GILBERT PROPERTY

FINAL ENVIRONMENTAL IMPACT REPORT SCH# 2007012075

PREPARED FOR
THE CITY OF OAKLEY

FINAL
ENVIRONMENTAL IMPACT REPORT
GILBERT PROPERTY PROJECT

**Figure 3-1
Western Area Power Administration Easement Rights Location**

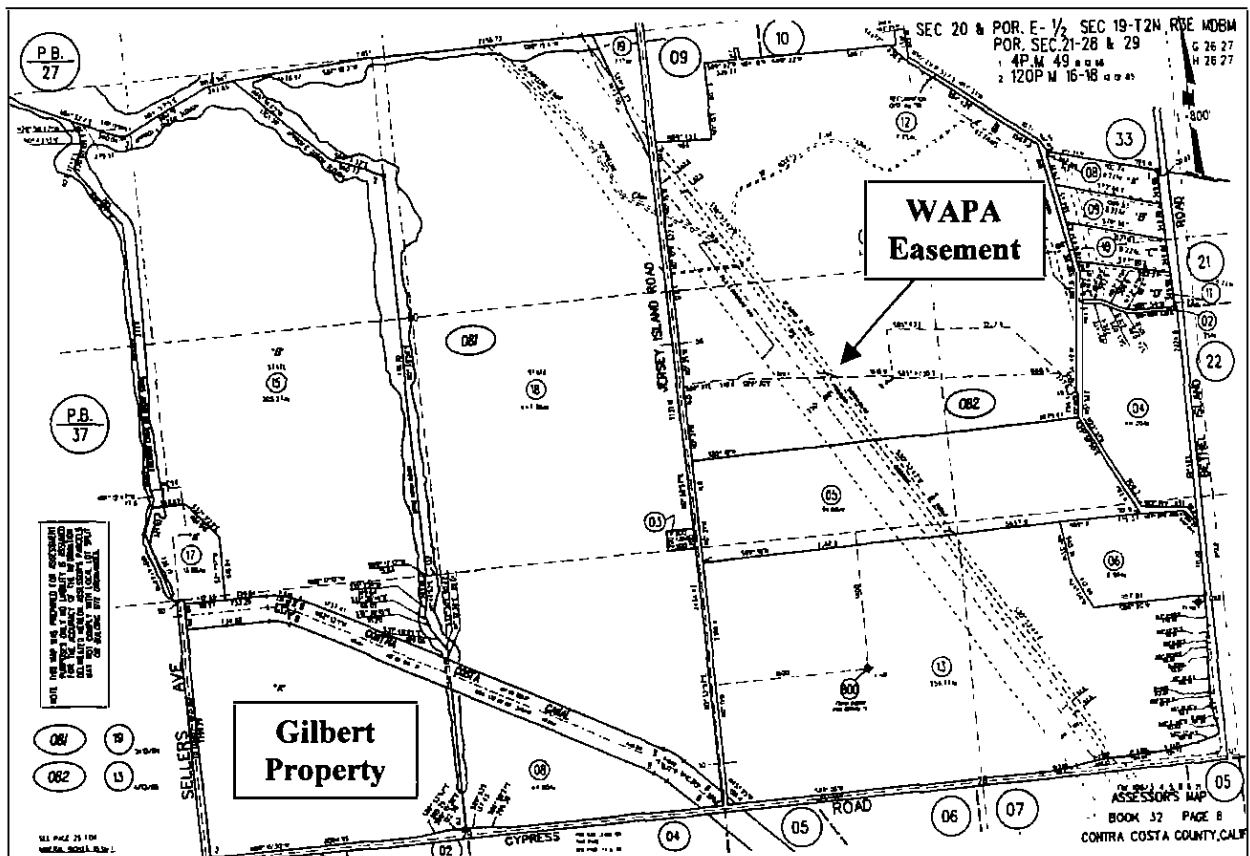
Thank you for the opportunity to comment on the Notice of Availability of the Draft Environmental Impact Report for the Gilbert Ranch Project (Subdivision 9033). The United States Department of Energy, Western Area Power Administration (Western), does not have any objections to the proposed use of Western's Olinda-Tracy 500-kilovolt transmission line easement, provided the project does not interfere with our easement rights and are in accordance with our general guidelines. The developers should obtain license agreements from Western prior to construction. Please have the developer submit the project specific improvement plans to Western for review and approval prior to construction.

The easement prohibits the following: (1) any use that will interfere with or damage the equipment of the United States, (2) digging or drilling of a well, (3) erecting buildings or structures, (4) placing or piling up material within the easement boundaries. The easement gives Western the right to remove trees, brush or other objects interfering with the safe operation and maintenance of the line.

The comment does not raise issues regarding the content of the DEIR. However, Contra Costa Assessor Map 32.8 shows the Western Area Power Administration Easement as located approximately 0.5 miles east of the project site (See Figure 3-1). Therefore, the easement will not be encroached upon and a license agreement is not required.
